APPLICATION NO.	FILING DATE	FIRST NAMED INVENTOR	ATTORNEY DOCKET NO.	CONFIRMATION NO
10/614,557	07/07/2003	Frank Yang	PAT-1512	5796
75	7590 11/24/2004		EXAMINER	
Raymond Sun			SZUMNY, JONATHON A	
12420 Woodhal Tustin, CA 92			ART UNIT PAPER NUMBE	
145, 011 72			3632	
			DATE MAILED: 11/24/2004

This is the third office action for application number 10614,557, Trash Can Assembly, filed on July 7, 2003. Finality of the previous office action has now been withdrawn.

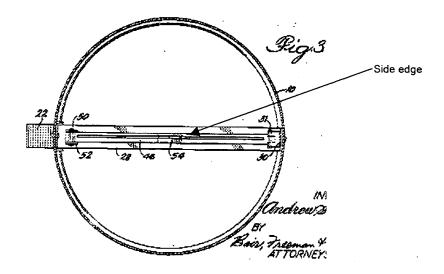
Regarding claims 2, 3, 5 and 7-9, Knapp '474 discloses a trash can assembly (above) comprising a shell (10) having top and bottom ends (above) wherein the bottom end has a side edge (above, the edge is on the bottom end, and the edge is on a side of a section of the bottom end), a liner (38) defining a container body and fitted inside the shell, a lid (18) fitted over the top end, a foot pedal (22) positioned adjacent the bottom end of the shell, a link assembly (20,30) coupling the foot pedal and the lid, and a support block/means (54, a "block" is defined in Merriam Webster's Collegiate Dictionary - 10th Edition as being "a compact usually solid piece of substantial material... to serve a particular purpose," so clearly 54 is a "support block") provided adjacent the side edge of the bottom end of the shell, wherein the liner has a bottom end that is supported by the support block when the liner is in a raised position, wherein the assembly includes a base (46, or alternatively 28) with the support block provided on the base, wherein the liner has an annular lip, wherein the top of the shell has an annular wall. However, Knapp '474 fails to specifically teach the annular wall to have a groove that exposes a portion of the upper lip of the liner.

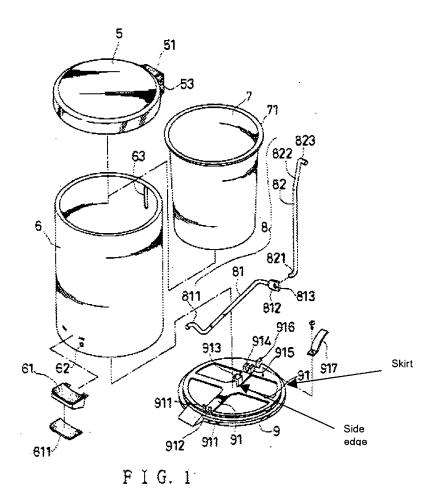
Meinzinger et al. '147 reveals a trash bag assembly (figure 7) comprising a shell, liner and trash bag, wherein the bag is first fitted in the liner and then the liner is seated in the shell (column 8, lines 51-59). It would have been obvious to one of ordinary skill in the art at the time the invention was made to have modified the method of Knapp '474 by fitting a bag into the liner before seating the liner into the shell so as to provide for a more sanitary assembly by only need to replace an inherently cheap and lightweight bag instead of the entire liner when the assembly is full of trash, in addition to providing an extra layer of material between the trash and rest of the assembly. Further, it would have been obvious to remove the trash bag when the liner is in a raised position with respect to the shell on the support block so as to facilitate

removal and replacement of the trash bag by providing a more convenient location with which to access the trash bag. Finally, an ordinary artisan would certainly recognize the need to remove and replace the trash bag when it becomes full. Moreover, Knapp '474 in view of Meinzinger et al. '147 further inherently teach the step of gripping an upper lip of the liner to raise the liner (via grip 40), but fail to specifically teach doing so via the groove. It would have been obvious to one of ordinary skill in the art at the time the invention was made to have positioned the grip to be in alignment with the groove so as to facilitate removal of the liner upon raising of the liner.

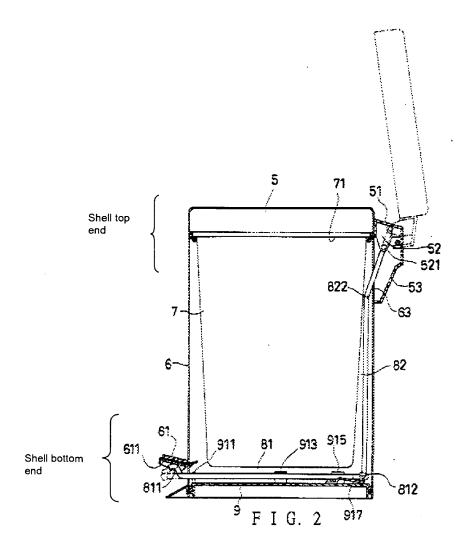
Wang '024 discloses a trash can assembly (above) comprising a shell (6) having top and bottom ends (above) wherein the bottom end has a side edge (above, the edge is on the bottom end, and the edge is on a side of a section of the bottom end), a liner (7) defining a container body and fitted inside the shell, a lid (5) fitted over the top end, a foot pedal (61) positioned adjacent the bottom end of the shell, a link assembly (81,82) coupling the foot pedal and the lid, and a support block/means (913, a "block" is defined in Merriam Webster's Collegiate

a particular purpose," so clearly 913 is a "support block") provided adjacent the side edge of the bottom end of the shell, wherein the assembly includes a base (9) with the support block provided on the base. However, Wang '024 fails to specifically teach the annular wall to have a groove that exposes a portion of the upper lip of the liner.
